The Egyptian Civil Aviation Authority requests and authorizes you to place the Response of EgyptAir to October 31, 2000 Submission of The Boeing Company regarding the EgyptAir Flight 990 investigation into the public docket for the EgyptAir Flight 990 investigation.

Response of EgyptAir  
to  
October 31, 2000 Submission of  
The Boeing Company  
Regarding  
The EgyptAir Flight 990 Investigation

Figure 14. Wheel Force from B-767 Ground Test Results Extracted from Boeing CD

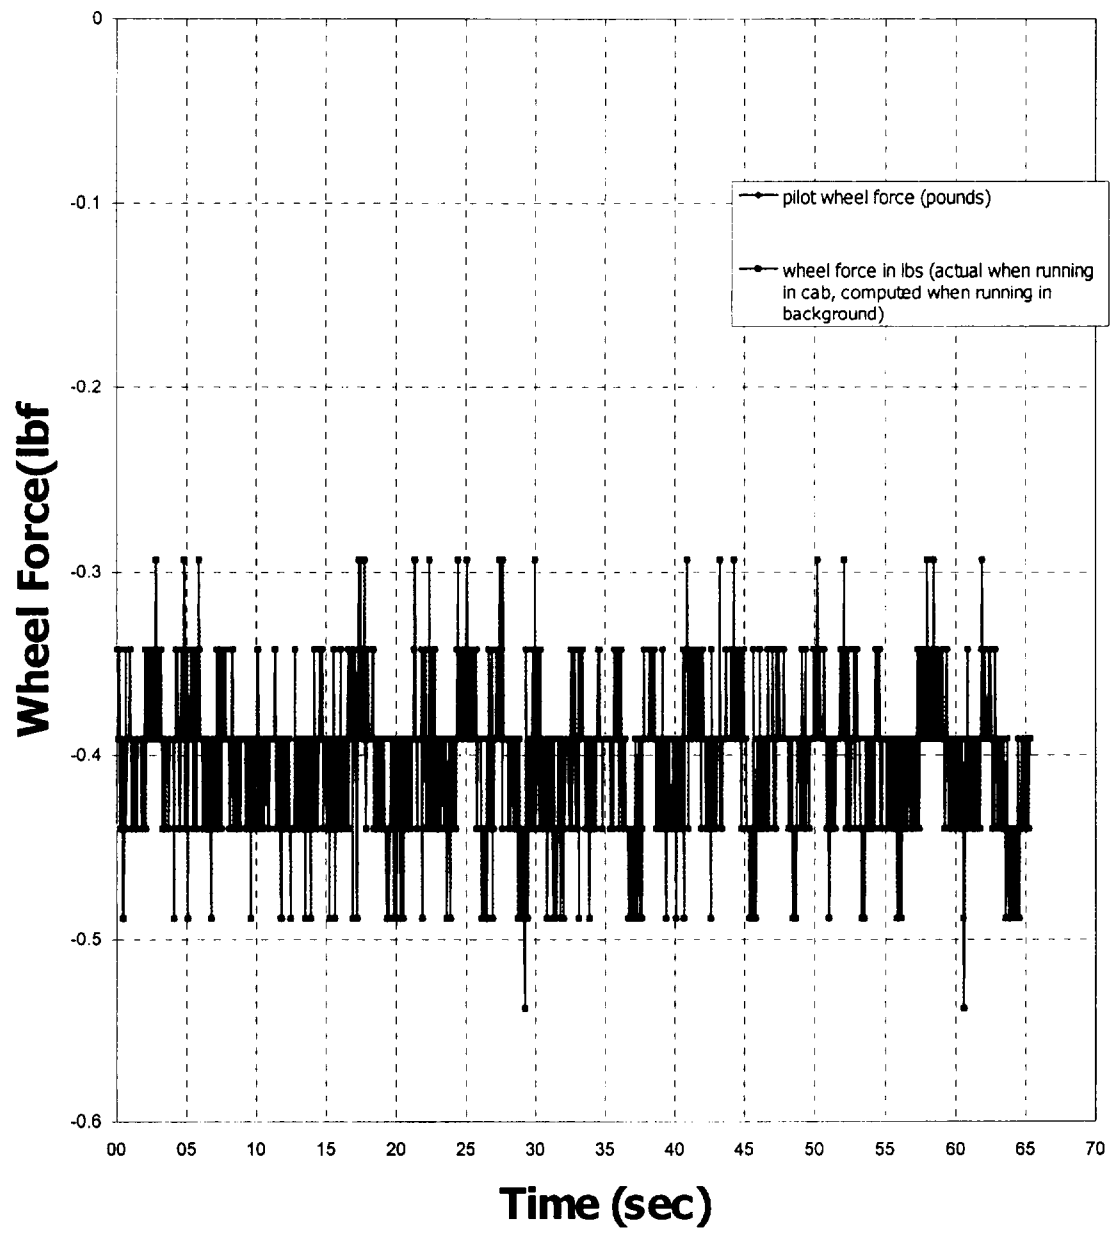
- The E-Cab data produced an unrealistic relationship between control wheel force and wheel movement (see Figure 14) and showed the movement of the outboard ailerons at speeds beyond the lockout speed (see Figure 15).

Figure 24. March Ground Test Data, Bias Changes for Captain and First Officer Column Force Measurements

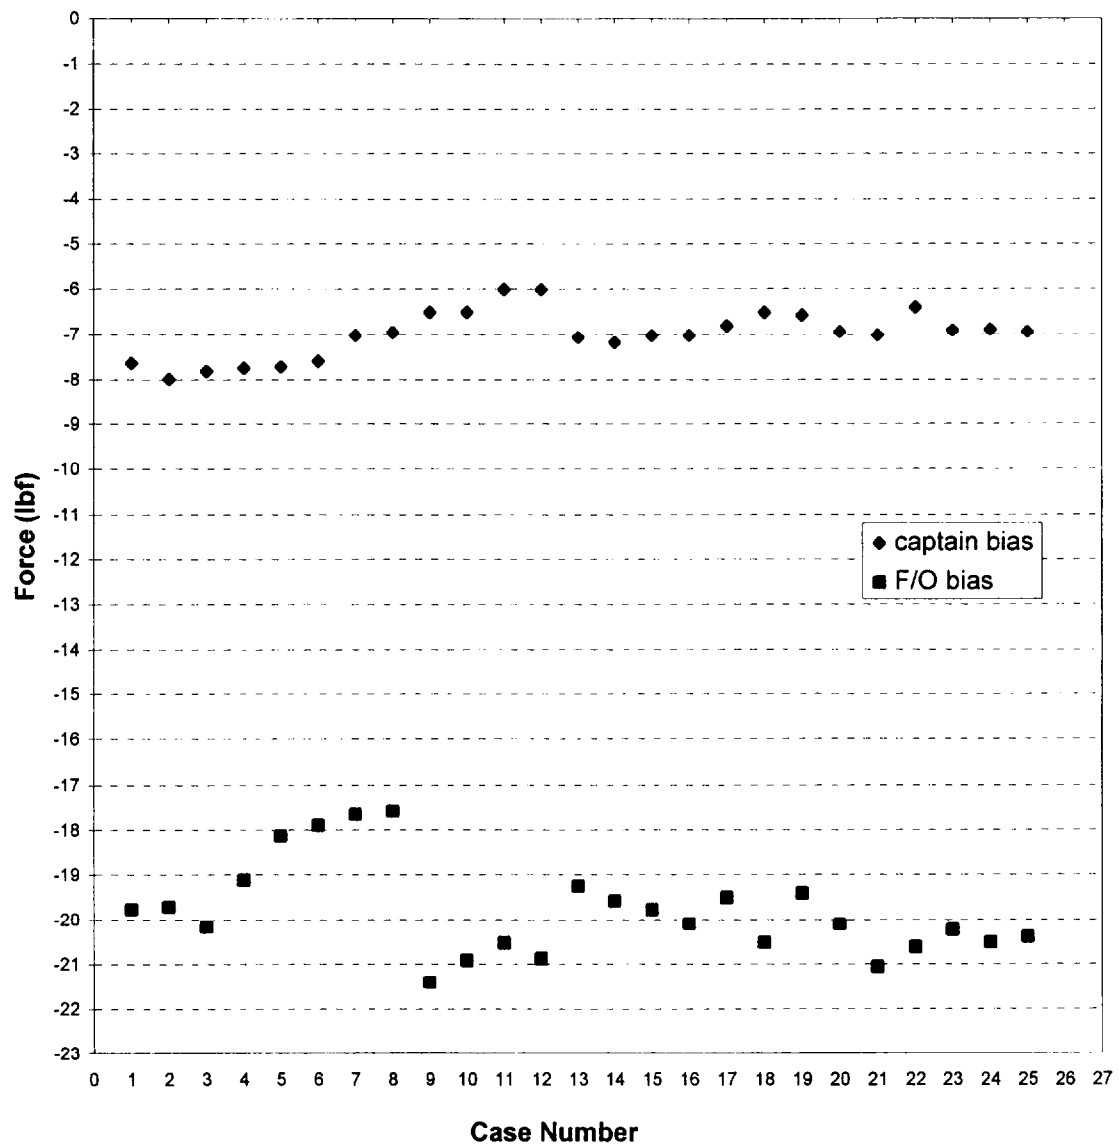
Further, Boeing's explanation of force bias due to temperature effects is not supported by the data. Figure 24 shows the bias on the Captain's column force measurement increasing with time, with the suggestion that changes in temperature caused this change in bias. If temperature were the cause of the change in bias, the bias in the First Officer's force measurement would have increased as well, but it decreased. In addition, the bias on the First Officer's force measurement does not change in the nearly linear manner that the bias on the Captain's force measurement does. If both force transducers have the same specifications, they should react to temperature in a very similar manner; there should not be an opposite reaction to changes in temperature.

Figure 25. April Ground Test Data, Bias Changes for Captain and First Officer Column Force Measurements

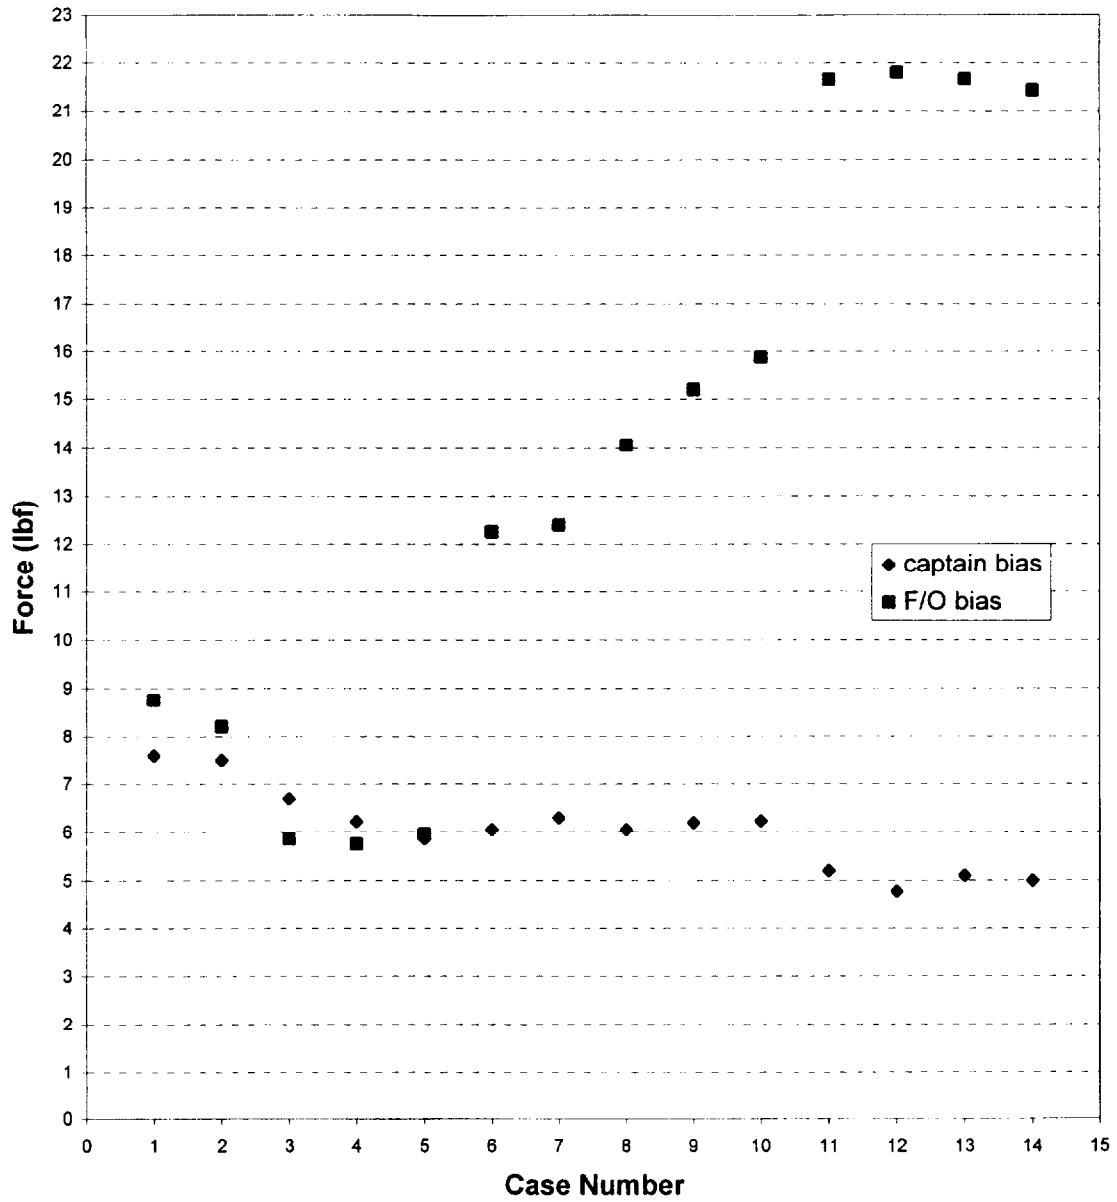
Figure 25 shows the bias during another test, but this time, the bias on the First Officer's force measurement increases much more rapidly than in the earlier test. This suggests that the temperature effects on the transducers are random because the temperature dependence more than triples between tests. Even if the temperatures had been recorded during the tests, that
